October 17, 1978

SUBJECT: POST-LOCA HYDROGEN PRODUCTION FROM MATERIALS INSIDE CONTAINMENT

MEMORANDUM FOR: Robert L. Tedesco, Assistant Director for Plant Systems, DSS  
FROM: W. R. Butler, Chief, Containment Systems Branch, DSS  
SUBJECT: POST LOCA HYDROGEN GENERATION FROM ZINC  
Reference: Memo for R. Tedesco from: S. Pawlicki, "Hydrogen Generation Rates after LOCA," March 15, 1978

MEMORANDUM FOR: W. R. Butler, Chief, Containment Systems Branch, DSS  
FROM: F. Eltawila  
THRU: J. Kudrick, Section Leader, Section A  
Containment Systems Branch  
SUBJECT: HYDROGEN GENERATION IN MARK II CONTAINMENT DUE TO ZINC  
CORROSION  
Reference: Memorandum for W. R. Butler from S. Pawlicki dated  
August 9, 1978

FIG. 4 Hatch-2 TEMP. TRANSIENT

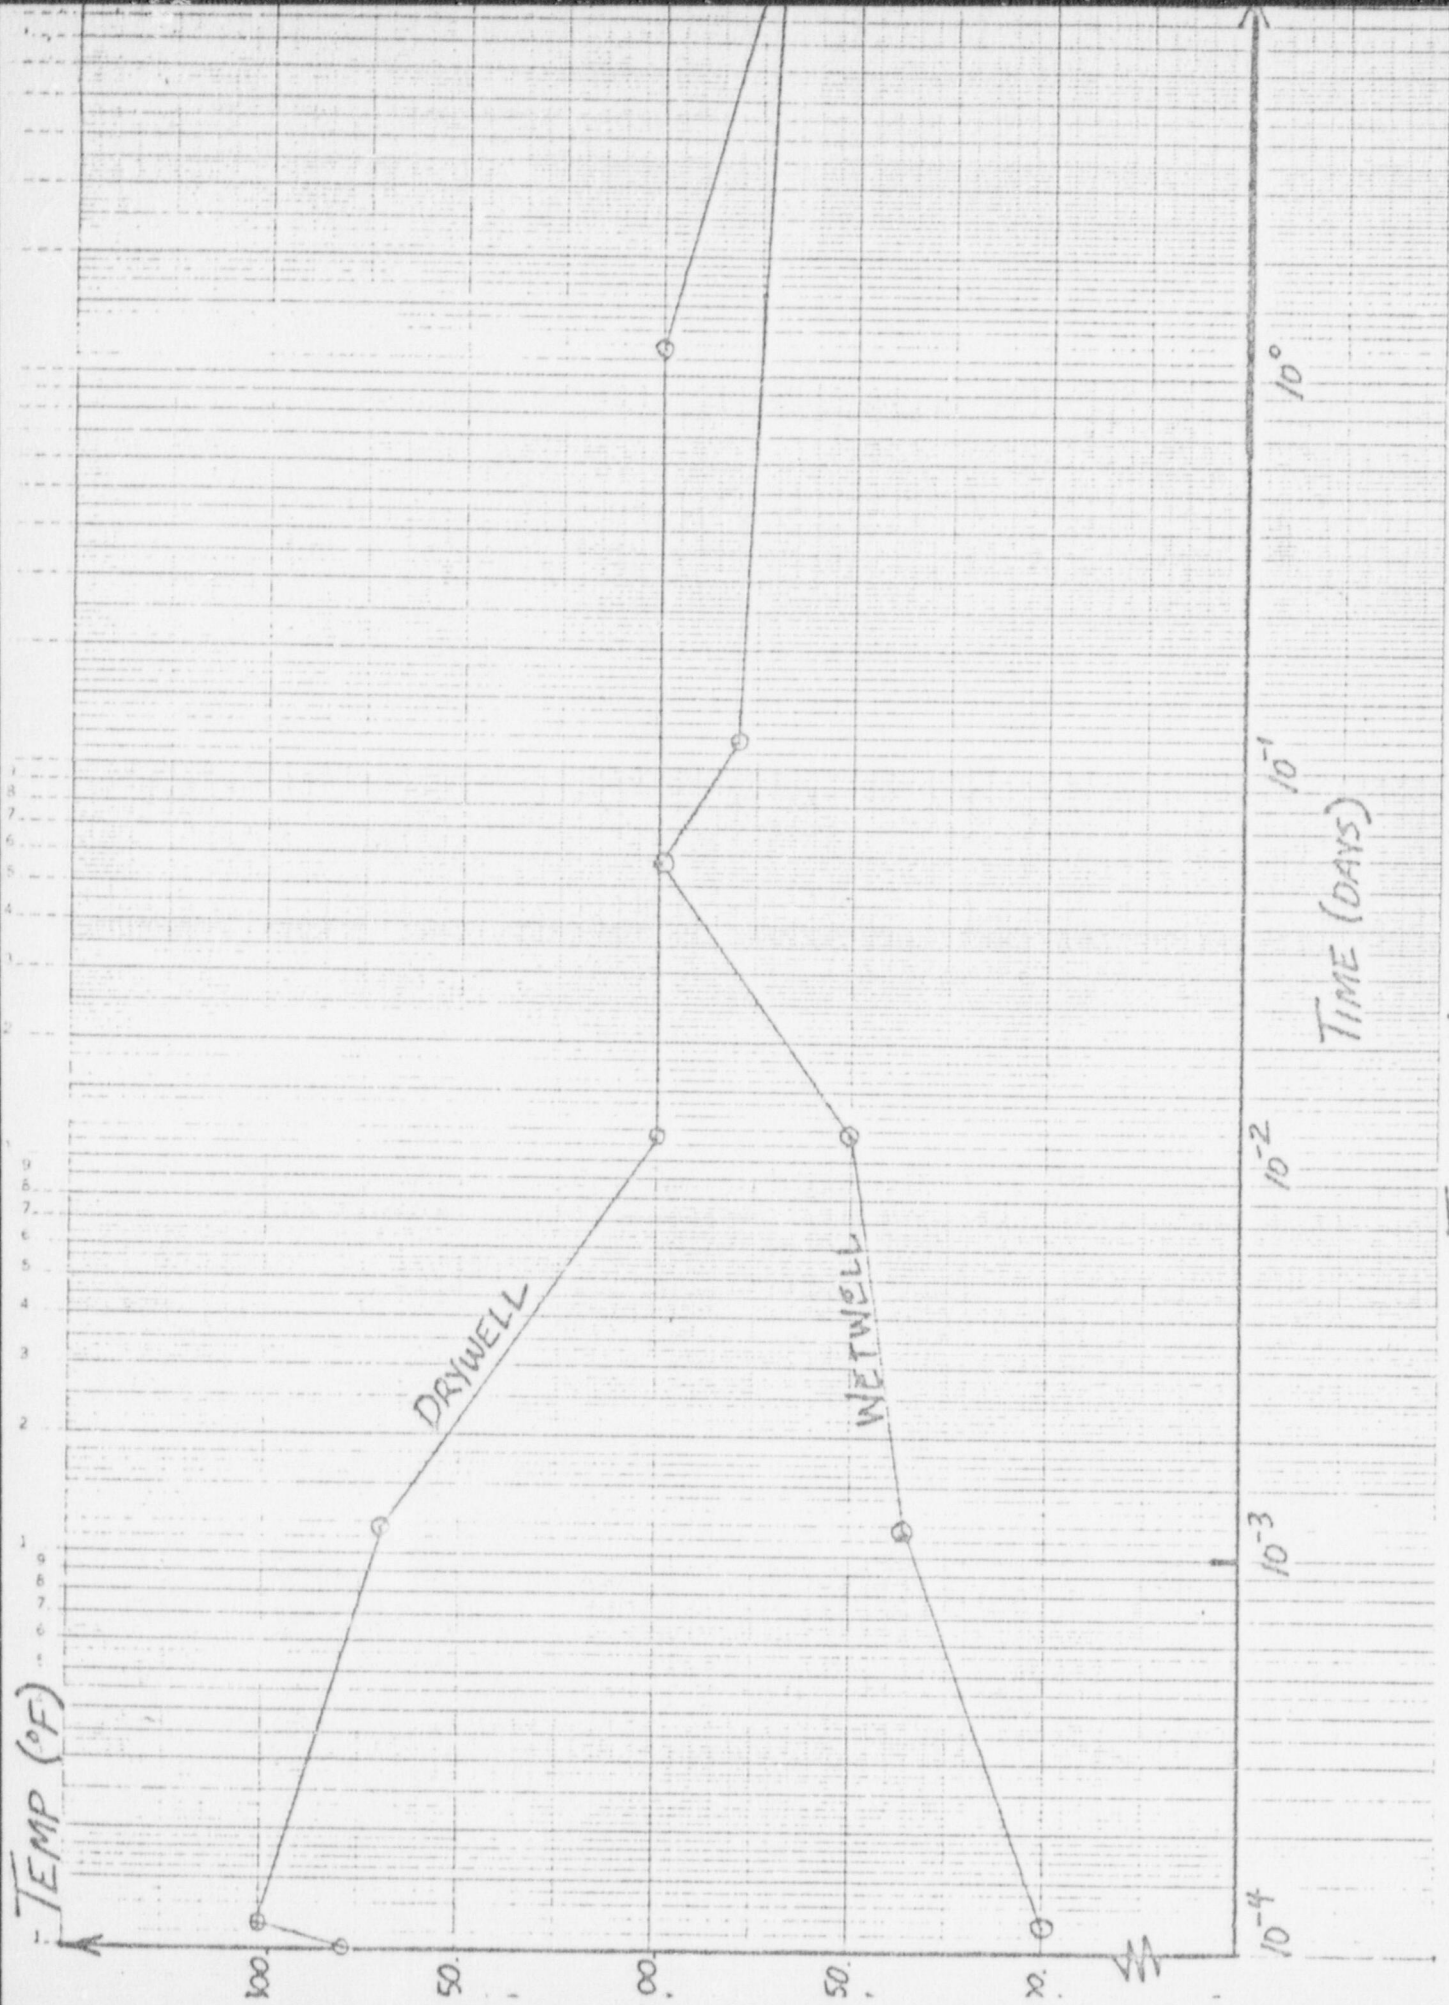
Figure 3 presents the calculated hydrogen concentration transient for the Hatch 2 plant (Mark I containment) using our estimates of zinc inside the containment since this information was not supplied by the applicant. Figure 3 also presents a comparison with a calculated hydrogen transient assuming no zinc was present. Figure 4 shows the post-LOCA temperature transient used to determine the zinc corrosion rates. It is apparent from the analyses performed that the effect of zinc, at least in the manner considered, was minimal for the Hatch 2 plant. This is probably due to the small surface area of zinc assumed to exist in the drywell and the relatively low post-accident temperature transient throughout the containment.

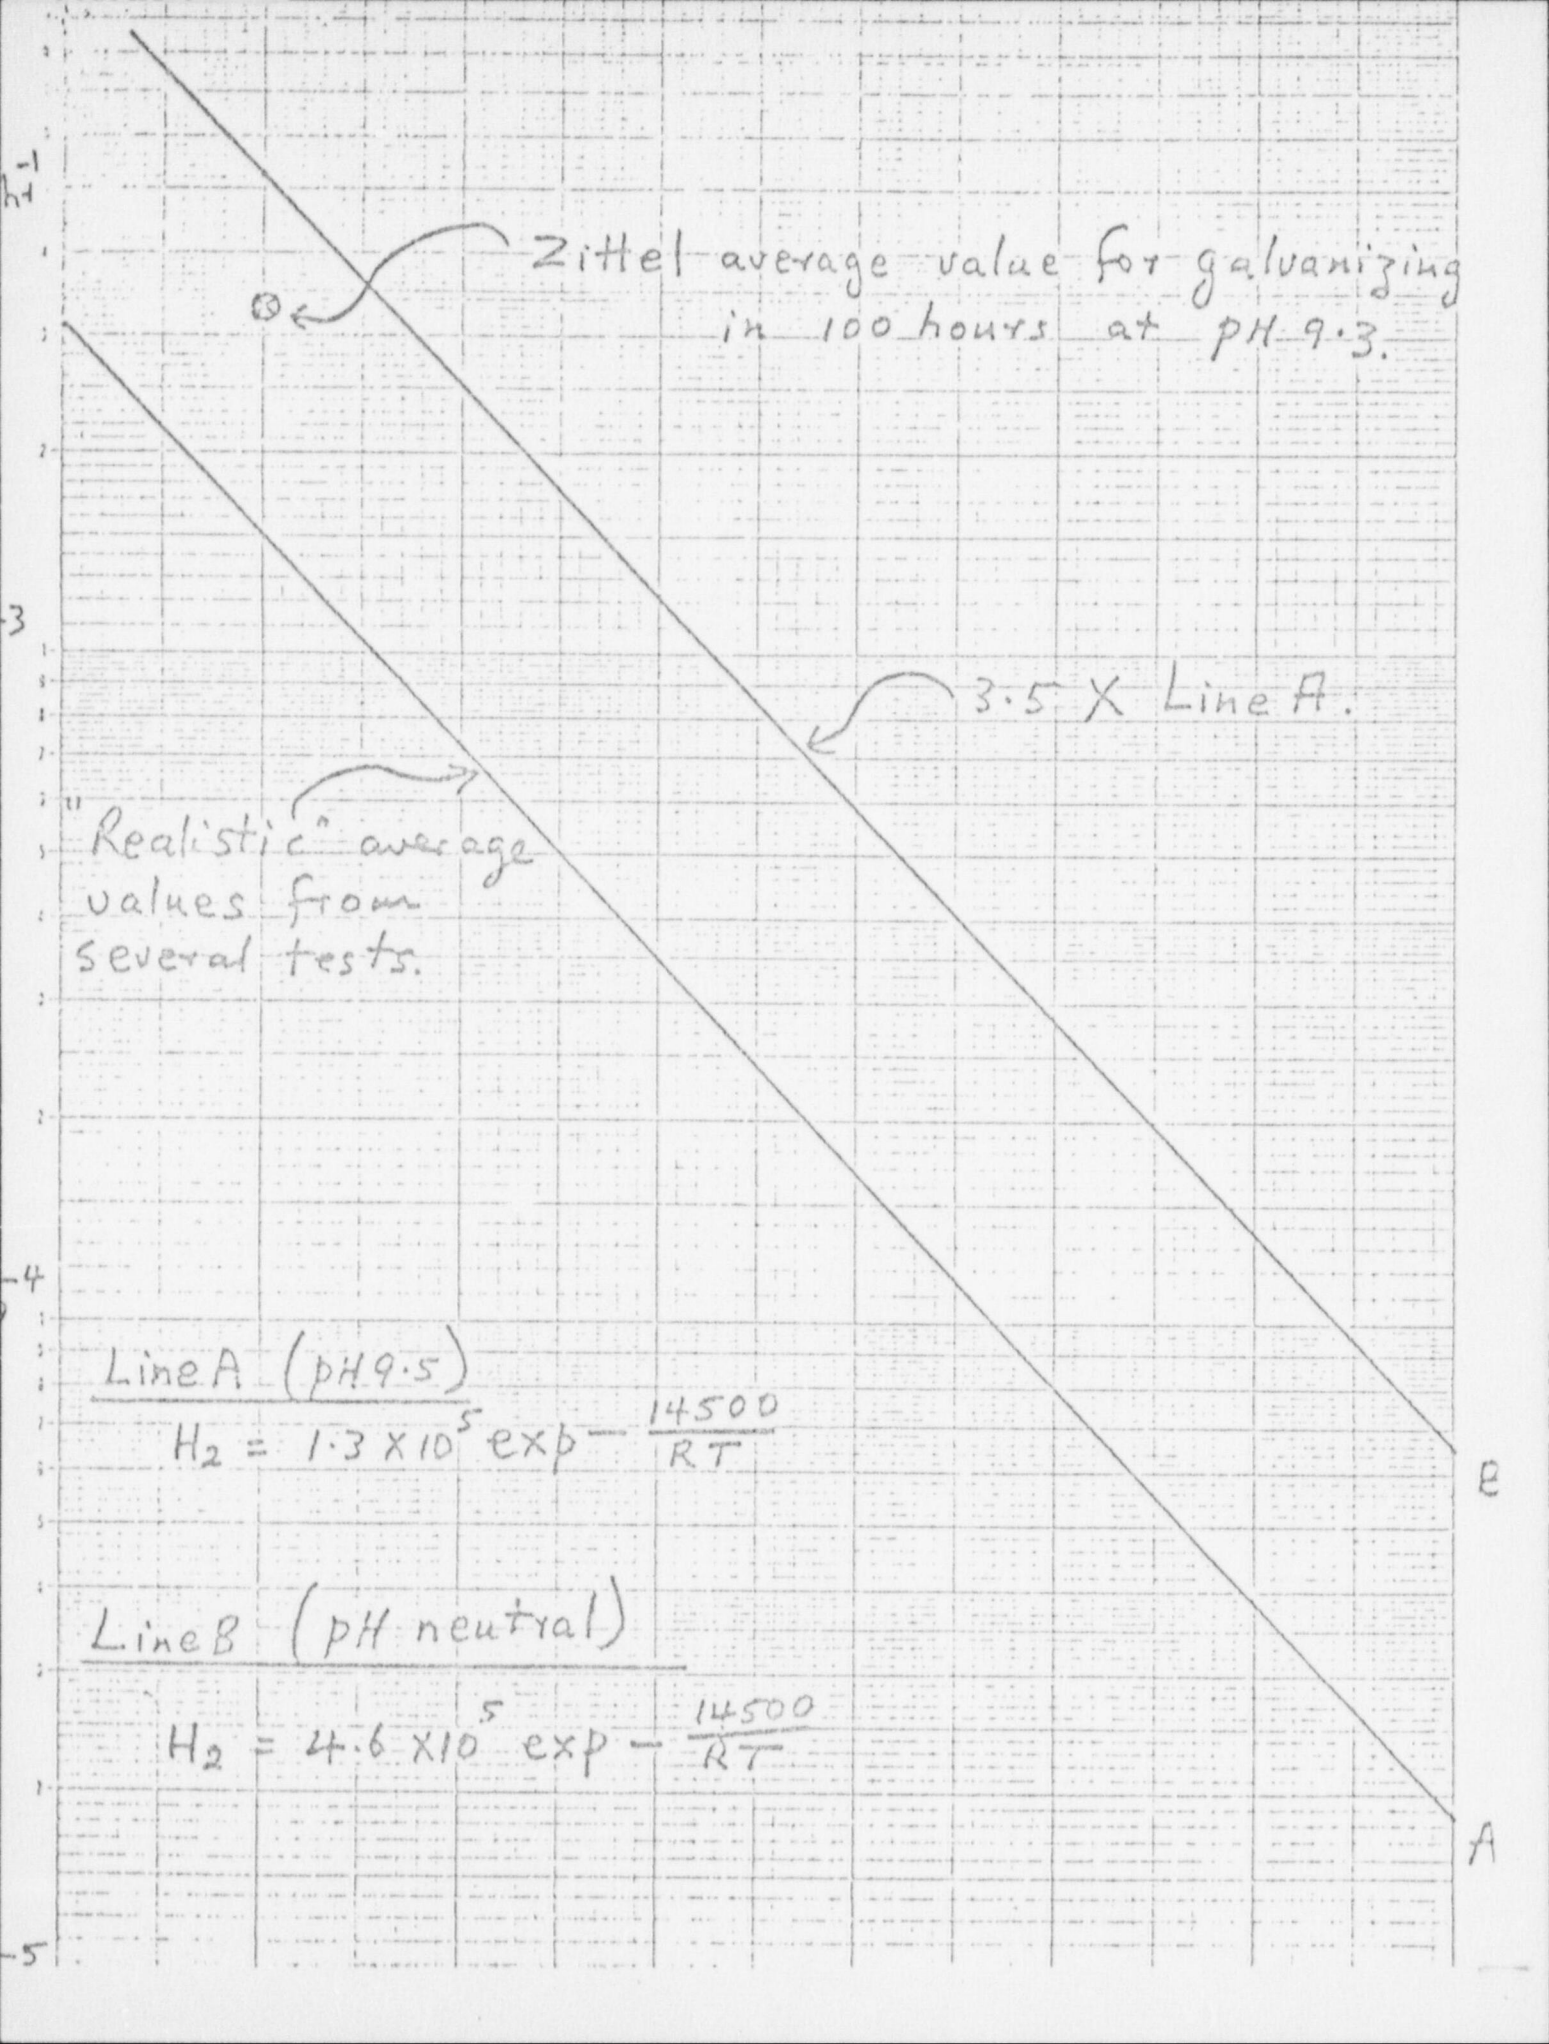
does not make a significant difference, so that the conclusion will apply to BWR neutral water sprays at pH 7. In Figure 14 of BNL-NUREG-24532 it is shown that the rate of H<sub>2</sub> release from Zn increases by a factor of 1.3 to 1.4 for each pH unit below 9. Therefore, the values for pH 7 are proposed as line B in Figure 1 attached, which is 3.5 times line A, and parallel to it. I use 3.5 because the pH in the field will probably be a little below 7.

Note that line B is identical to Figure 11 of BNL-NUREG-24532.

Hydrogen Generation by Corrosion of Zinc  
and Zinc-base Paint

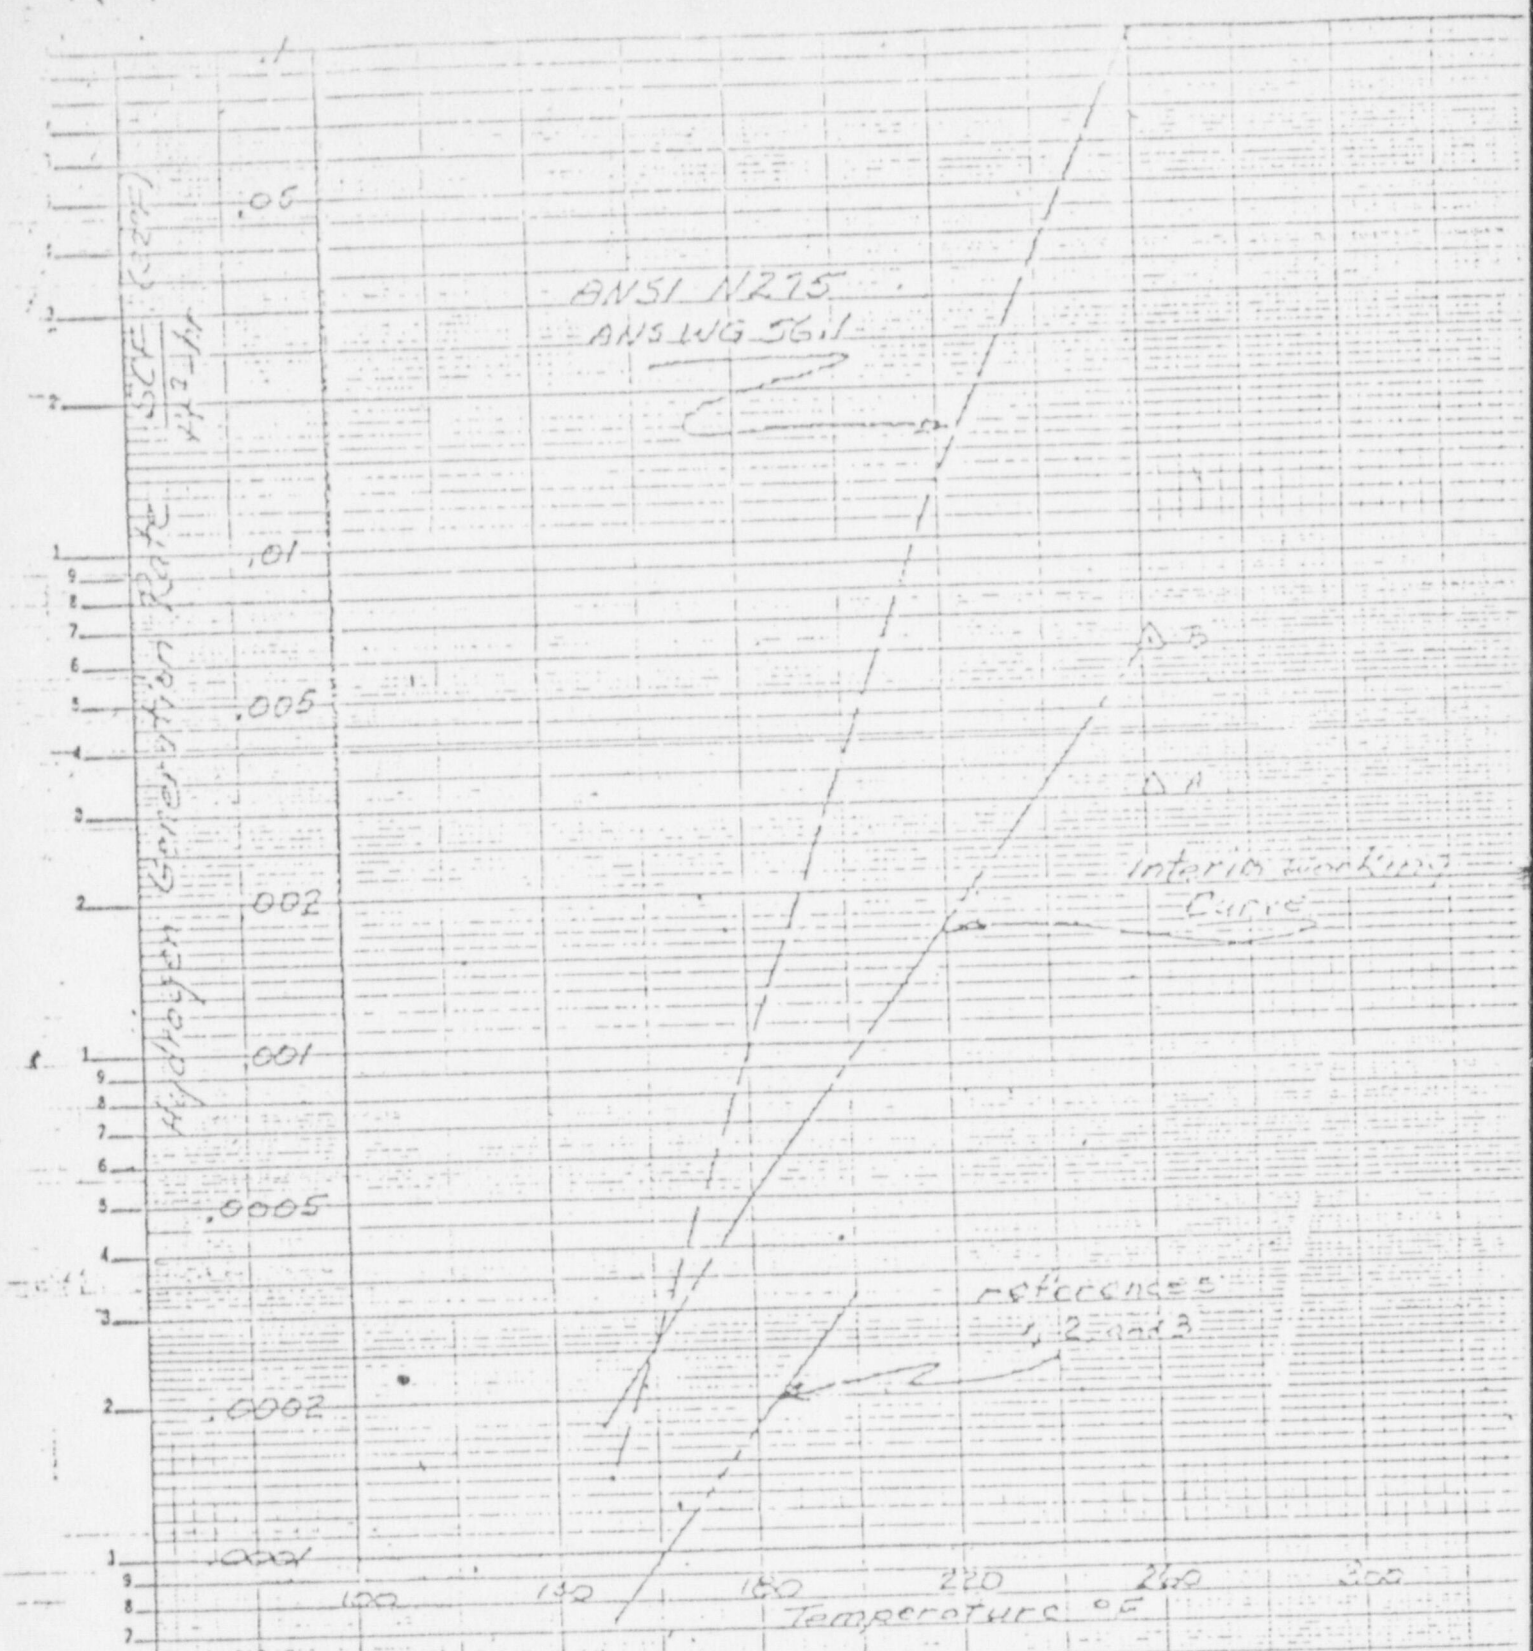
For example, we attempted to determine the experimental basis for the zinc hydrogen generation rates reported in the ANSI WG56.1, ANS N-275 draft standard, but were unsuccessful. We contacted various members of the working group who indicated that the data were based primarily on Franklin Institute work (1, 2). Our own derivation of a hydrogen generation curve from the Franklin Institute data provided the lower curve in Attachment 1 covering only the temperature range from 150°F to 200°F. This curve was corroborated by an independent set of measurements reported by S. E. Turner (3) to the ANS 56.1 Working Group. Zittel at ORNL (4) has reported hydrogen generation rates due to the corrosion of zinc and zinc-base coatings (Points A and B respectively) at 265°F.

Since there is a theoretical basis for expecting a straight line semi-log relation between rate and temperature, to the first approximation, we have drawn a line through the uppermost Zittel point parallel to the data of References 1, 2 and 3. We thereby define an upper limit that encompasses all the limited data that we now have on hand. We recommend that this curve be used for calculating hydrogen generation rates in the interim, until we develop additional data.
